HGY/2023/0338: Mallinson Centre: objection re. Ecology and biodiversity

Highgate Conservation Area Advisory Committee strongly objects to this application. The plans for the Mallinson site pose serious threats to biodiversity and ecosystems both on site and in the neighbourhood.

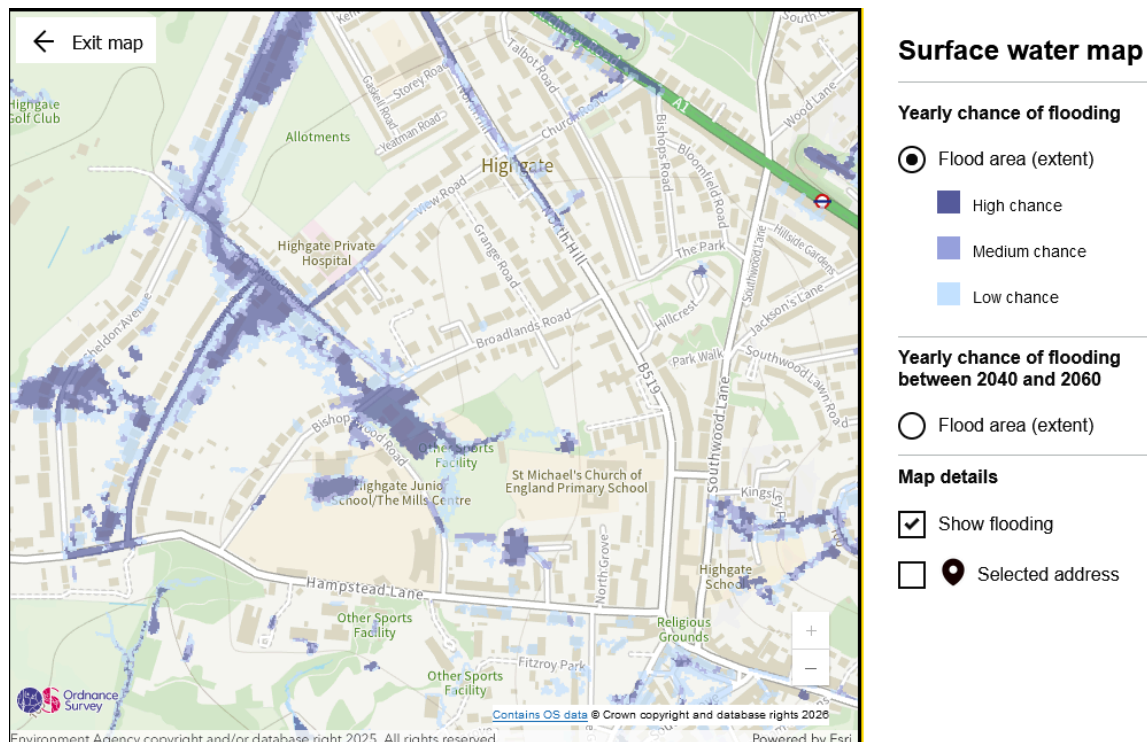
2. The Mallinson Site cannot be taken in isolation. It is part of important green corridors from Hampstead Heath through Highgate to Highgate and Queen's Wood, Waterlow Park and so-on (see Highgate Neighbourhood Plan and more recent work on Ecological Corridors by the HNF, for instance). It is also an integral part of the hydrology of the surrounding area. The interconnections between trees, various habitats, the hydrology, neighbouring gardens and the Heath should be taken far more seriously than in this planning application.

Damage or loss to integral parts of such ecological corridors cannot be made up for by developers providing cash for more greenery somewhere else in the borough. Damage to or destruction of one part of an ecological corridor damages the whole.
